**REPLY TESTIMONY**  
**OF**  
**ROBERT M. FAGAN AND PATRICK LUCKOW,**  
**SYNAPSE ENERGY ECONOMICS,**  
**ON BEHALF OF THE OFFICE OF RATEPAYER**  
**ADVOCATES**

Order Instituting Rulemaking to Integrate  
and Refine Procurement Policies and  
Consider Long-Term Procurement Plans  
Phase 1a

**(R.13-12-010)**

San Francisco, California  
October 22, 2014

12 **Figure 1. Capacity Headroom – Trajectory Scenario**

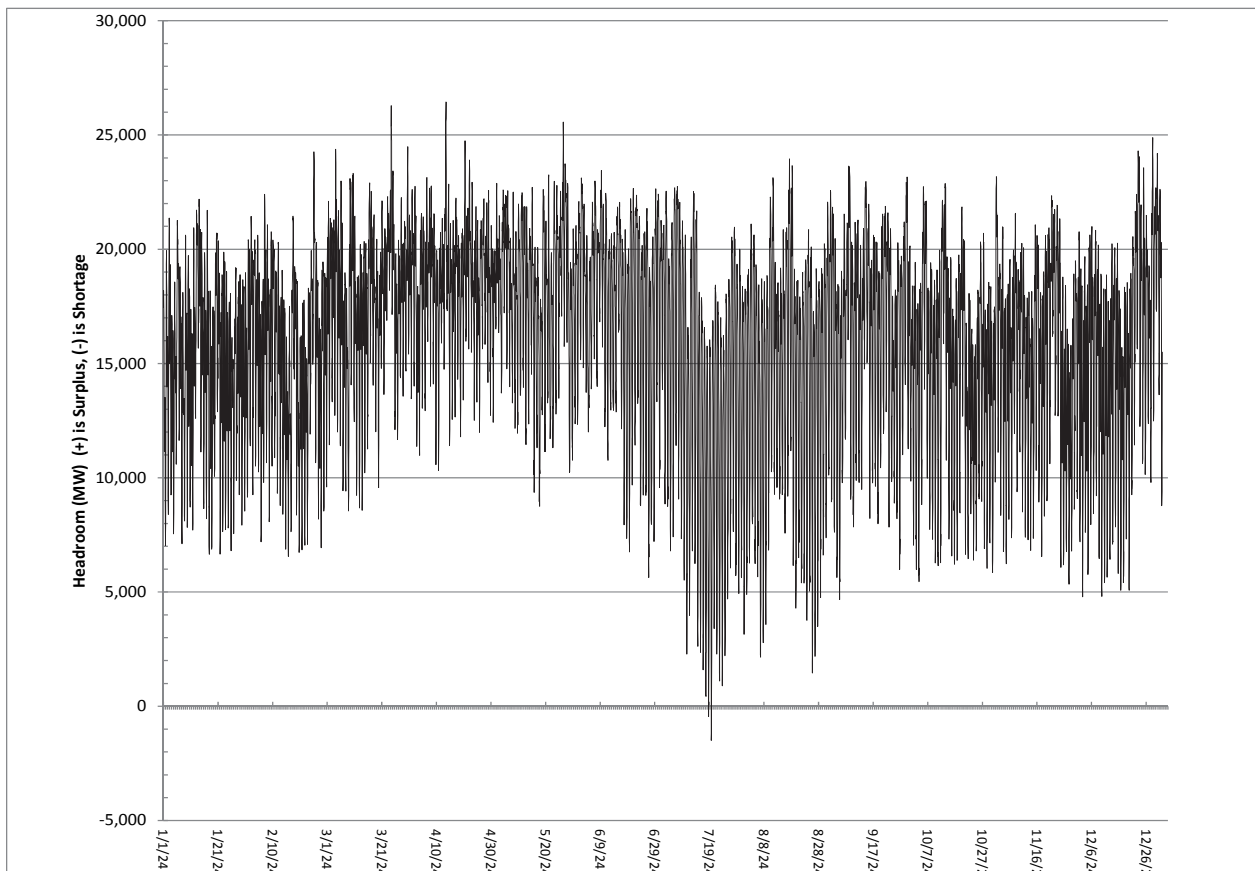
4 A.11. No, not necessarily, because even though the model curtailed renewable resources  
5 during those spring intervals, significant amounts of capacity remain available during  
6 those periods to serve as potential “additional” flexible supply if required under scenarios  
7 where renewable energy was curtailed at lower levels than seen in the Phase 1a results.  
8 For example, as seen in Figure 1 of ORA’s August 13, 2014 opening testimony and  
9 reproduced below, considerable capacity headroom exists in the Trajectory Scenario  
10 during the spring months. Generally, upwards of 5,000 MW of headroom exists over all  
11 spring months and more than 10,000 MW of headroom exists during April.
